## ArevaEPRDCPEm Resource

**Advanced Response to**

**Request for Additional Information No. 335, Question 03.08.04-10**

**Question 03.08.04-10:****Follow-up to RAI Question 03.08.04-5**

**Figure 03.08.04-10-1—Hydrodynamic Pressure on SFP Walls due to Seismic Load in -Z (vertical down) Direction**

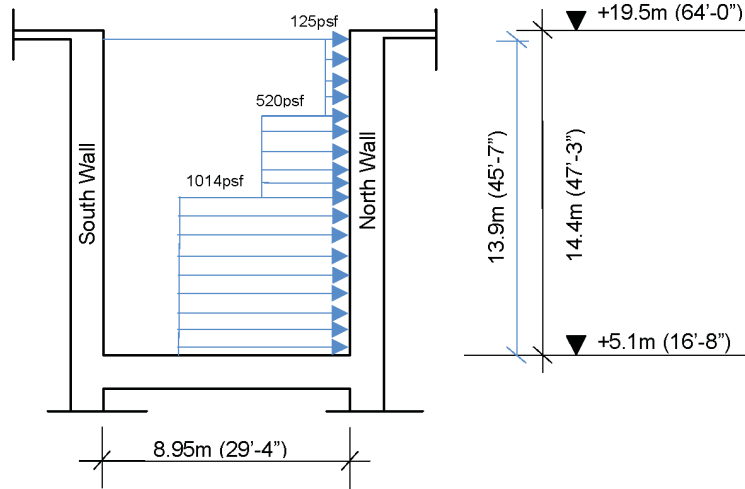
The staff notes that FSAR Section 9.1.2 (Revision 1) mentions that the design of the spent fuel storage racks is the responsibility of the COL applicant and makes only general statements regarding design loads, (Section 9.1.2.1 Item 10) and required dynamic and stress analyses (Section 9.1.2.3). Similarly, the response to RAI 155, Supplement 2, Question 3.8.1-7 makes only general statements regarding design load cases. Therefore, this information does not address the intent of the RAI.

Since the spent fuel storage racks are free-standing, and their analysis and design is deferred to the COL application, AREVA at this stage needs to clarify how they determined the loads imposed on the spent fuel pool. Both the procedure to determine the loads and the magnitude of these loads (e.g., sliding, rocking, twisting, impact on the pool walls and slabs) need to be described. This information should be included in the relevant sections of the FSAR so that, when the detailed design of the storage racks is actually carried out, the COL applicant can perform the necessary comparison between the assumed loads and the loads obtained from the detailed analysis. The applicant is requested to describe the analysis and procedures for the spent fuel pool and racks, and explain how they compare to the criteria in Appendix D to SRP Section 3.8.4, "Guidance on Spent Fuel Pool Racks." Include this information in the FSAR.

Elaborate on how the hydrodynamic loads are determined and provide a summary of the relevant calculations for the spent fuel pool. This summary should include the magnitude of convective and impulsive masses, corresponding frequencies, and a description of the methodology used to convert the dynamic effects of these water masses to loads applied to the static FE model. Confirm if the same methodology is used for the other seismic Category I pools in the U.S. EPR.

The equivalent static SFP loads applied in the NI analysis are not the Technical Report TN-Rack.0101 loads. The SFP design loads from racks and water in the pool are calculated separately and are applied in the overall ANSYS NI model as equivalent static pressures on SFP wall and slab. The rack equivalent static loads are based on estimated pool fuel capacity and previous nuclear plant rack analytical data, while the SFP water loads (and other NI pool loads) are determined following the methodology of the TID-7024, "Nuclear Reactors and Earthquakes." The methodology for calculating the SFP hydrodynamic loads is consistent with the method described in the Response to RAI 412, Question 03.07.02-74. The design loads used for SFP analysis are compared to the maximum wall pressures determined through post-processing of the whole pool multi-rack dynamic analysis results, and are verified as adequate. This response provides details on how the design loads are calculated for the NI Pools and the ESWB Pools. The hydrodynamic loads and analysis for the spent fuel pool and liquid storage tanks are described in U.S. EPR FSAR Tier 2, Sections 3.8.3.4.4 and Section 3.8.4.4.1, respectively.

The SFP rack loads used in the static analysis of the NI consist of rack, fuel weight and rack seismic forces, which are applied in the overall ANSYS model as pressure on the walls and pool slab. Rack loads are conservatively based on 1400 cells versus the planned capacity identified

- Lateral seismic load on the SFP walls, resulting from rack horizontal movement during a seismic event, is calculated and applied on the SFP walls up to an elevation corresponding to assumed height of the racks. A hydrodynamic pressure of 12.08 psi and based 0.3 g acceleration is selected using previous nuclear plant rack analytical data. The hydrodynamic pressure is increased with the seismic acceleration along the height of the racks on 3.28 ft (1m) increments. The seismic acceleration used is linearly increased between the top and bottom of the racks using the peak acceleration from the in-structure response spectra (ISRS) at the SFP slab (four percent damping curve), and acceleration from the next available ISRS. The pressure magnitude changes from 17,021 psf at the rack
